From: Tracey Genrich [Tracey.Genrich@frasercoast.qld.gov.au]
Sent: Wednesday, 23 September 2015 7:40 PM
To: COHEN Dan
CC: CLAYBOURN Dayna; BATTEN Denise; WILSON Tracey (EHP)
Subject: Re: RPEQ Certification Letter - Kingfisher Parade Toogoom Seawall

Kingfisher Parade Seawall – RPEQ certification

Kingfisher Parade Seawall – RPEQ Certification

SEAWALL MONITORING SURVEY OF
SEAWALL CONSTRUCTION
KINGFISHER PARADE
TOOGOOM

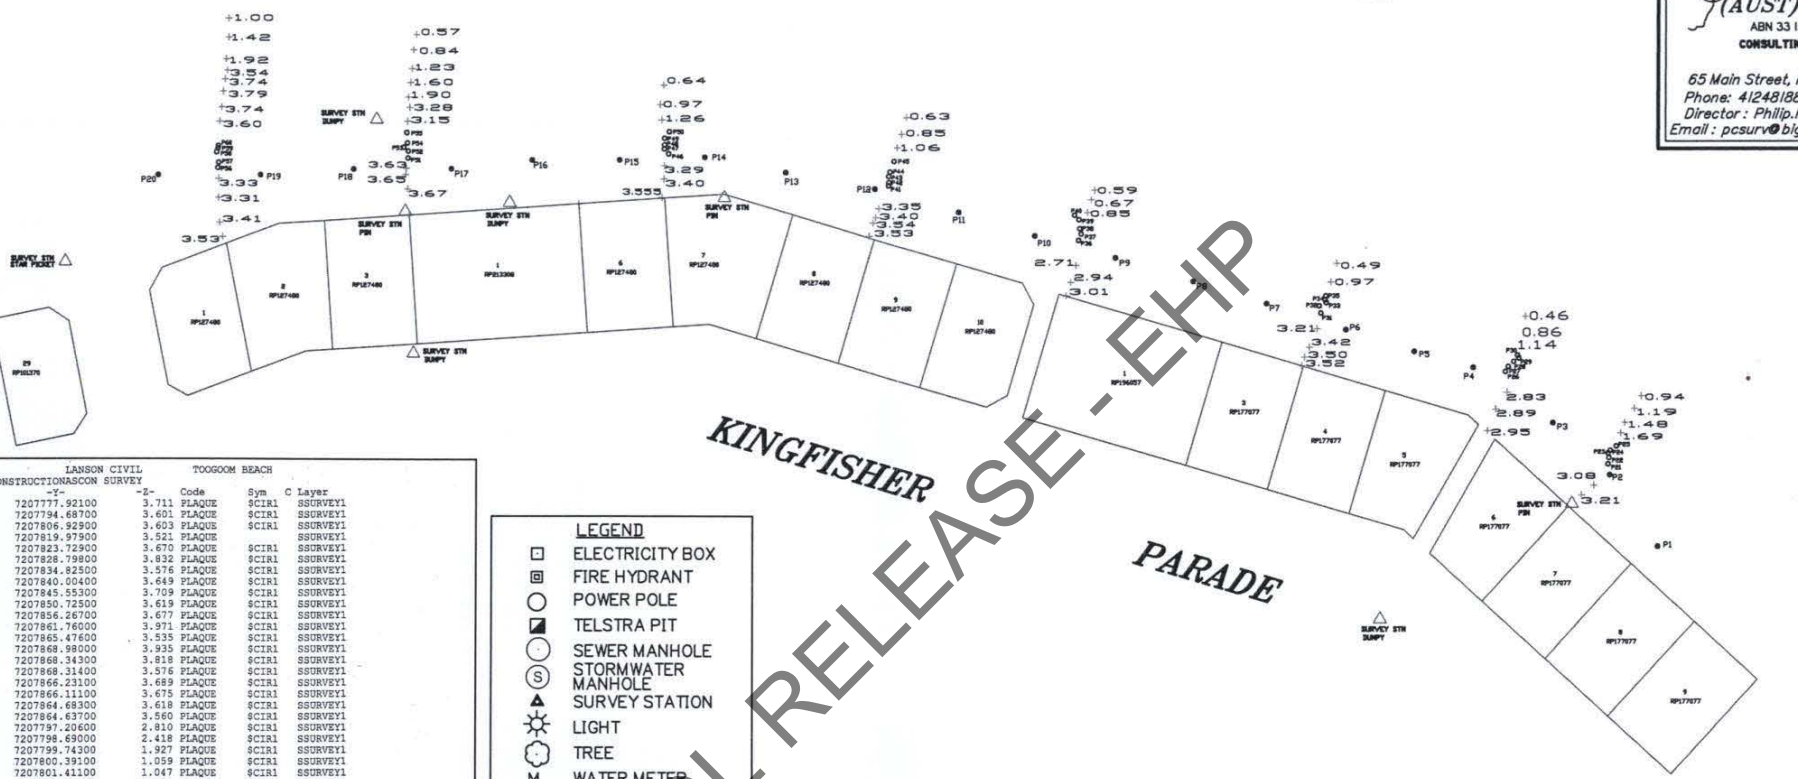
The surveyor has surveyed 35 plates out 60, which is 9 more than during the 10 November visit. I guess they used a shovel to find some of these plates i.e. 17, 18, etc... With a likelihood of 23 covered with sand and 1 "missing plate". We observed that plate 48 is supported by a broken armour rock.

In term of main statistics, that would be "1.6% plate lost" (plate 31) and "1.6% rock damaged" (rock 48). As indicated in our memorandum following the site visit, the rock damaged is likely to be mechanical or accidental rather than due to "weathering" (7 x equal-sized "fresh" broken pieces is unlikely to have occurred over a period of time but rather instantaneously).

This "preliminary" survey, 1 year after completion, suggests a dilapidation rate of up to 1-2% per year. This preliminary dilapidation rate is to be confirmed in 2019 (or following the next "big" storm event), by a more detailed condition survey.

I think it would be useful to glue another "Plate 31", since it is missing so that we can observe this point later-on. Maybe this can be done during next maintenance? It's not critical though (it's only 1 plate over 60..) although next time, I highly recommend to equip the surveyor with "replacement plates". Please, could you discuss this with Rosalyn and Brooke?

Also, could the surveyor provide a comment on what they have observed at that location 31? Is the plate missing BUT some glue is still there attached to the rock (i.e. the rock has not moved but the glue "failed") OR is it impossible to find any trace of the plate at all (could be that a rock movement, etc..)?

Plaque 31 appears to be missing.
Plaques 22-25,29-30,33-35,38-40,45,
51-60 are covered by sand and not found.
